UNITED STATES PATENT AND TRADEMARK OFFICE

APPLICATION NO.	FILING DATE	FIRST NAMED INVENTOR	ATTORNEY DOCKET NO.	CONFIRMATION NO.
10/538,402	07/21/2006	Hui Wang	495152002400	3574

Office Action Summary	Application No. 10/538,402		Applicant(s) WANG ET AL.	
	Examiner BRYAN D. RIPA		Art Unit 1795

DETAILED ACTION

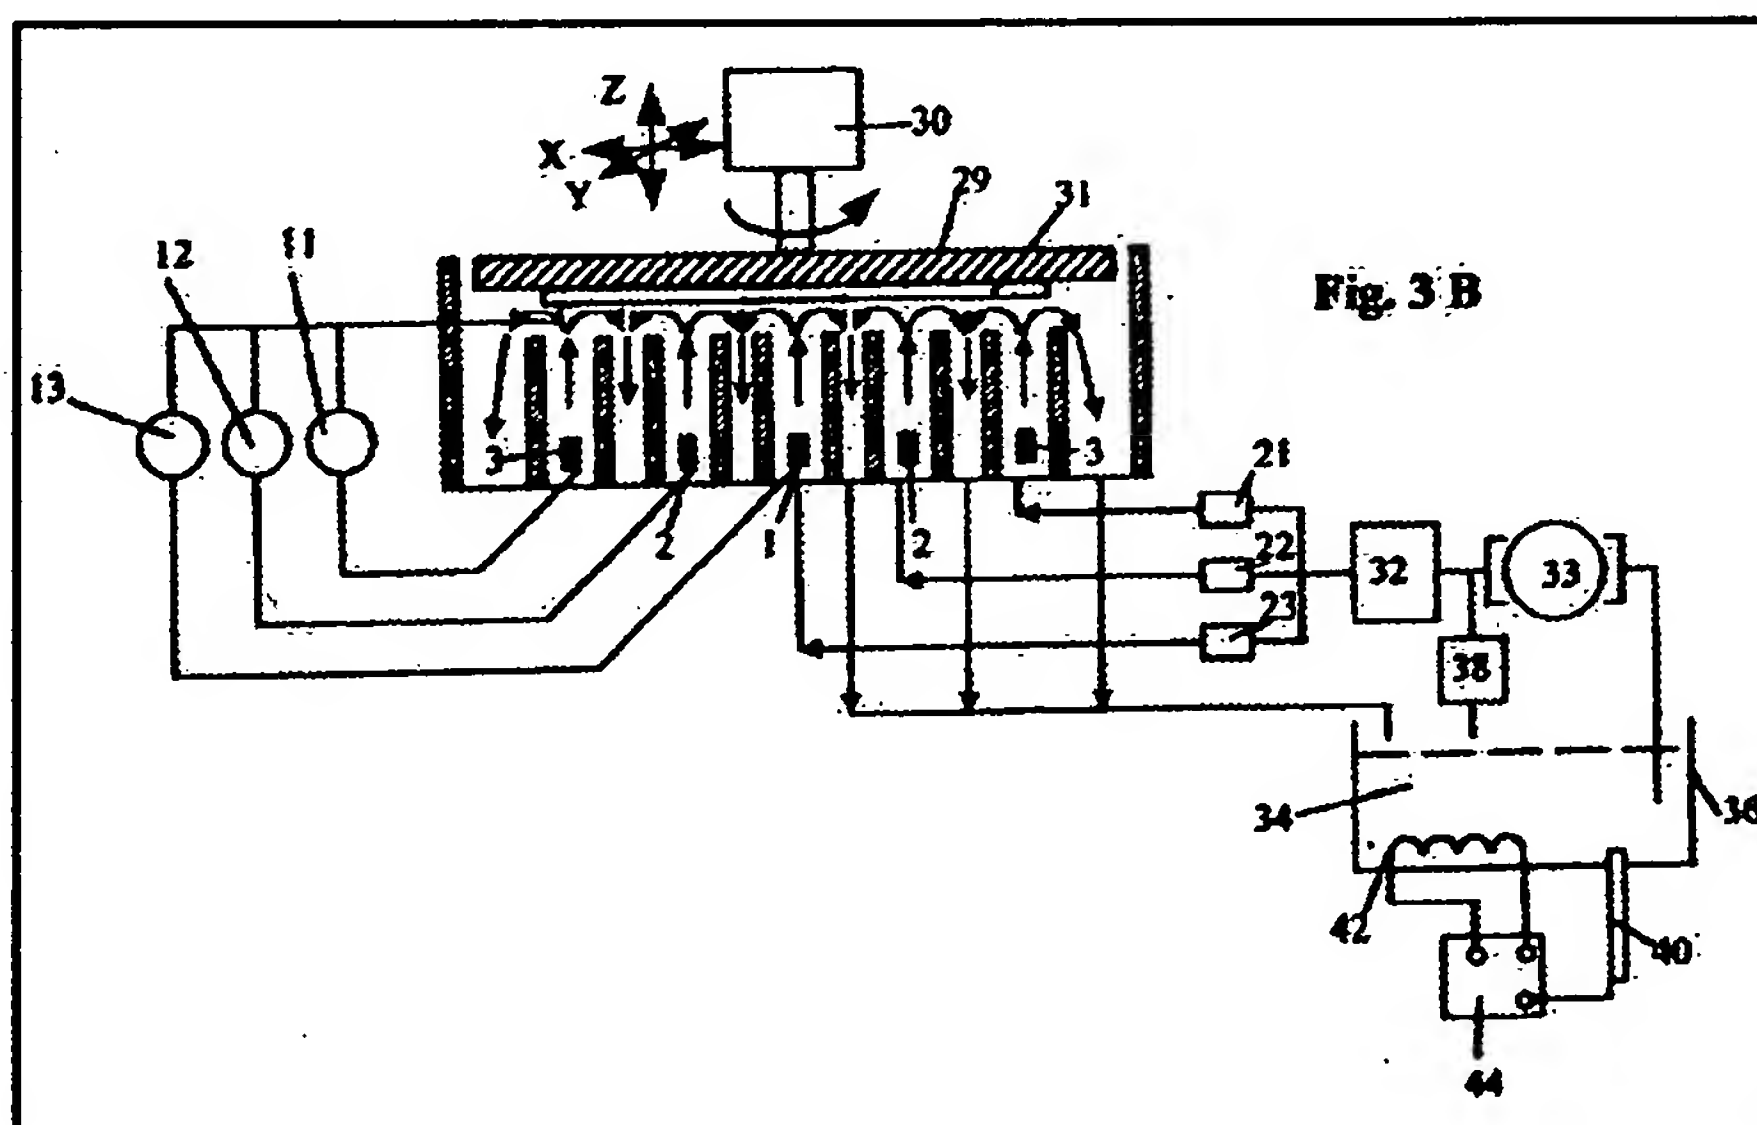
- a receptacle having a plurality of section walls (see figure 3b below showing a cup-type receptacle having a plurality of section walls; see also page 27 line 26- page 28 line 16); and
- a wafer chuck configured to hold the semiconductor wafer and to position the semiconductor wafer within the receptacle with a surface of the semiconductor wafer adjacent to top portions of the plurality of section walls (see 29 below).

Regarding claim 4, WANG teaches the apparatus for electropolishing and/or electroplating metal layers on a semiconductor wafer wherein the plurality of section walls are cylindrical and concentric (see figure 3b above).

- positioning a wafer chuck holding a semiconductor wafer within a receptacle having a plurality of section walls, wherein a surface of the semiconductor wafer to be electropolished or electroplated is positioned adjacent to top portions of the plurality of section walls (see wafer chuck 29 and figure 3b above showing a cup-type receptacle having a plurality of section walls; see also page 27 line 26-page 28 line 16).

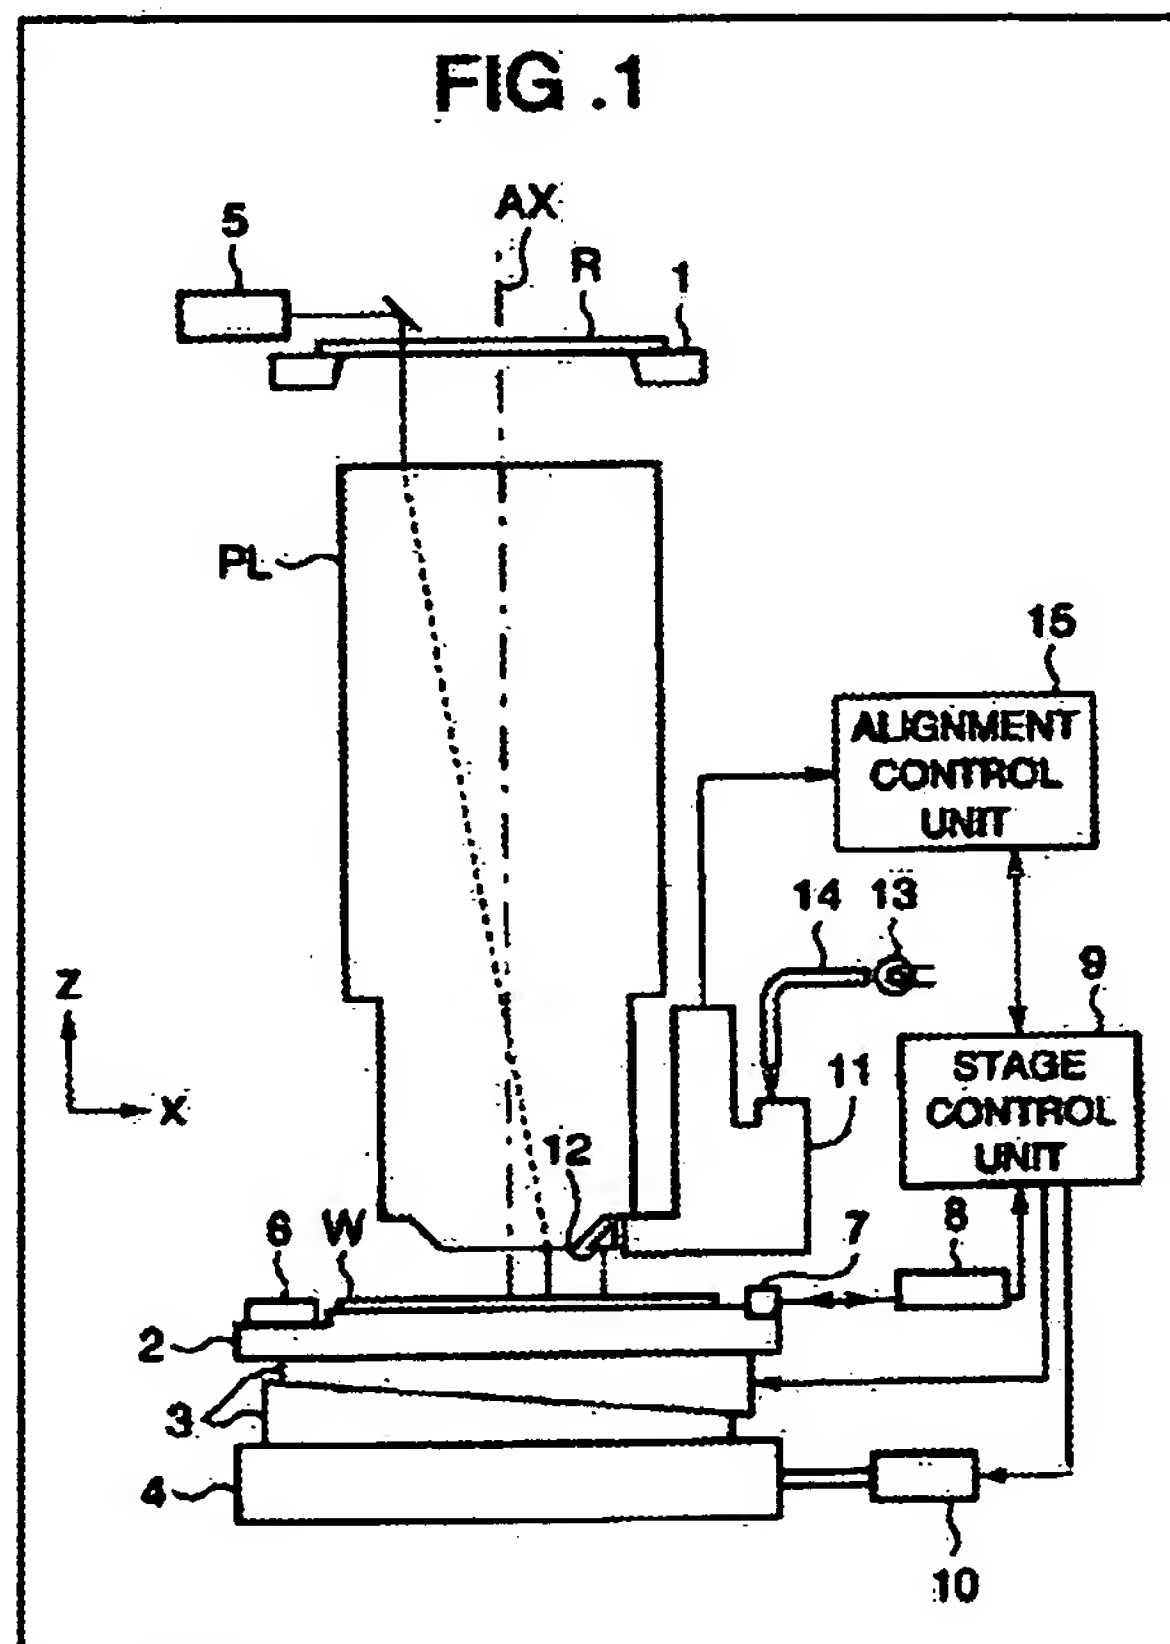
MIZUTANI, however, teaches the use of sensors to measure alignment of a wafer holder having a wafer disposed within it and an exposure apparatus (see laser interferometer 8 in figure 1 below; see also col. 3 lines 51-58).

MIZUTANI, however, teaches the use of sensors to measure alignment of a wafer holder having a wafer disposed within it and an exposure apparatus (see laser interferometer 8 in figure 1 above; see also col. 3 lines 51-58).
